## HISTORIC AND DESIGN REVIEW COMMISSION

**HDRC CASE NO:** 2025-019  
**ADDRESS:** 330 MISSION ST  
**LEGAL DESCRIPTION:** NCB 944 BLK LOT SW 108.72 OF 35  
**ZONING:** RM-4, H  
**CITY COUNCIL DIST.:** 1  
**DISTRICT:** King William Historic District  
**APPLICANT:** MICHAEL PEREZ/AGUA VERDE ENTERPRISES, INC.  
**OWNER:** MICHAEL PEREZ/PEREZ MICHAEL  
**TYPE OF WORK:** Carport enclosure, front walkway replacement, and front door replacement  
**APPLICATION RECEIVED:** January 17, 2025  
**60-DAY REVIEW:** March 18, 2025  
**CASE MANAGER:** Bryan Morales  
**REQUEST:**

1. Enclose an existing carport to create approximately 396' sf of living space and to construct an approximately 120' sf attached covered porch.
2. Replace existing front walkway with a brick paver walkway.
3. Replace the existing front door.

FRONT ELEVATION  
GARAGE TO ADU CONVERSION: 330 MISSION ST

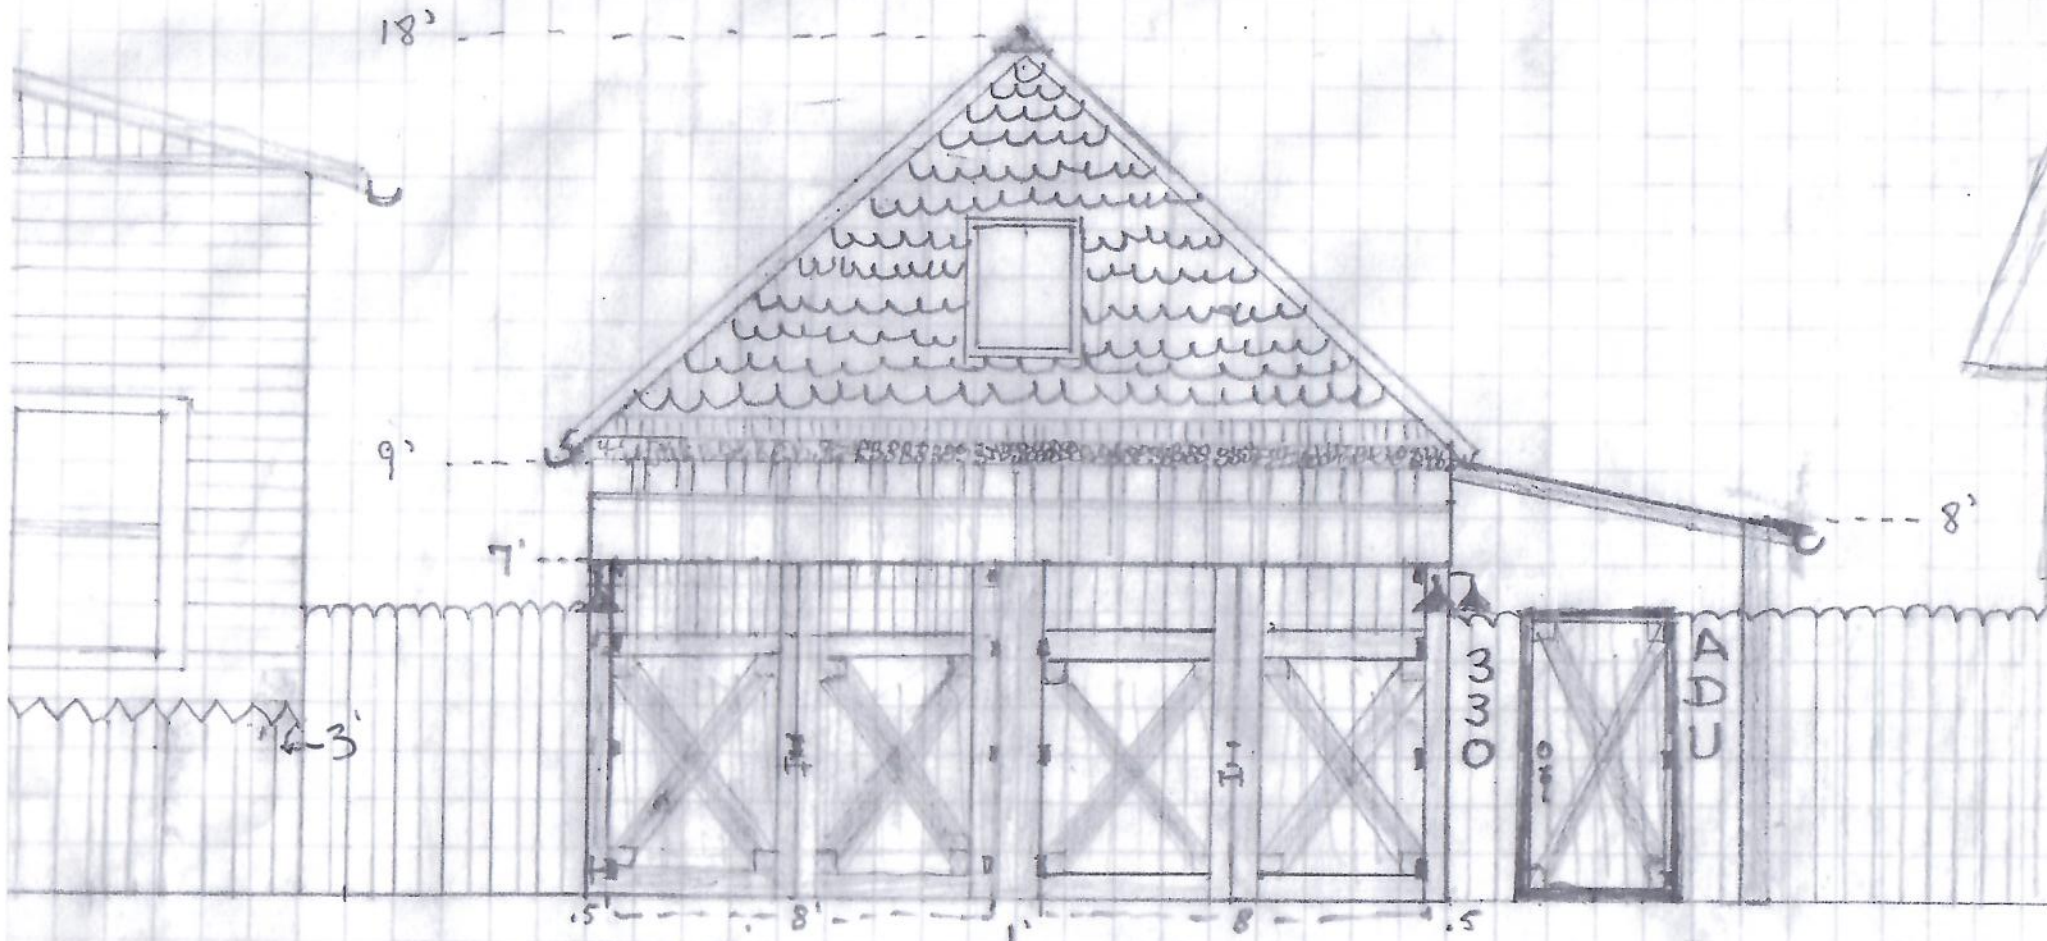
- h. ARCHITECTURAL DETAILS (FENESTRATION PATTERN) (CARPORT ENCLOSURE) – The applicant is proposing to install two garage door bays on the front elevation; one pedestrian door, a transom window, and two four-over-four windows on the right elevation; and a sliding door system approximately 18' wide on the rear elevation. The Guidelines for New Construction 2.C.i. related to window and door openings stipulates to incorporate window and door openings with a similar proportion of wall to window space as typical with nearby historic facades. Staff finds the proposed fenestration pattern generally appropriate; however the left elevation should incorporate additional window openings.

- iv. That the applicant install a fully wood garage door or a garage door with a design that mimics wood construction and features a smooth finish without a faux wood grain texture. Final garage door specifications must be submitted to staff for review and approval prior to the issuance of a Certificate of Appropriateness.
